BILL PROCTOR RE: Bid Title: Fred George Greenway Museum and Nature Center Renovation District 1 Bid No: BC-02-27-14-22 JANE G. SAULS Opening Date: February 27, 2014 at 2:30 PM District 2 JOHN DAILEY ADDENDUM #1 District 3 Dear Vendor: This letter serves as Addendum #1 for the above referenced project. BRYAN DESLOGE The following shall be added to the bid specifications: District 4 **KRISTIN DOZIER** Addendum to the plans and specifications, attached. District 5 MARY ANN LINDLEY Acknowledgment of this addendum is required as part of your bid submittal. At-Large Failure to acknowledge this addendum may result in rejection of your bid. NICK MADDOX Should you have any questions, feel free to call me at (850) 606-1600. At-Large Sincerely, VINCENT S. LONG Jm Krikhal County Administrator

Addendum Issued 20 February 2014 BFBA #14050

## ADDENDUM NUMBER 1 TO THE CONTRACT DOCUMENTS

Fred George Greenway Community Center BFBA Project Number - 14050

Attachment "a", dated 19 February 2014

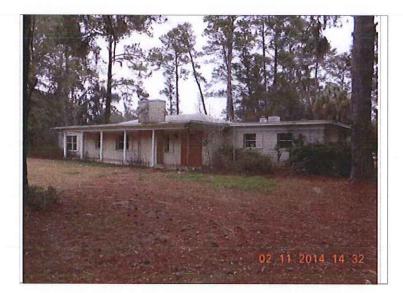
Item No. 8:	The Basis of Design for the vinyl "wood plank" flooring called out in the Room Finish Schedule is Hallmark Luxury Vinyl – "El Dorodo" – Valencia Teak; Trinity Tile, 115 SW 49 Ave, Suite 105, Ocala, FL, 34474. (866) 774-3390.
Item No 9:	Provide new columns and base plate attached to existing anchor bolts in accordance with Attachment "a", date 19 February 2014.
Item No. 10:	Hazardous materials are present in the building as documented in Attachment "b" - Asbestos Survey Report. Bidders shall assume that there is no asbestos abatement required in the Project Requirements for this Bid.

NEW COLUMN AND BASE RATE MATCH EXISTING SIZES REPAIR SLABAFTER COLUMN INSTALLE REUSE EXISTING ANCHON BOLTS PROJECT NAME FREP GEONGE CALCULATED BY SHEET No. \_\_\_\_\_ JOB No. \_\_\_\_\_ SCALE \_ DATE attachment "a" 19 Formary 2014
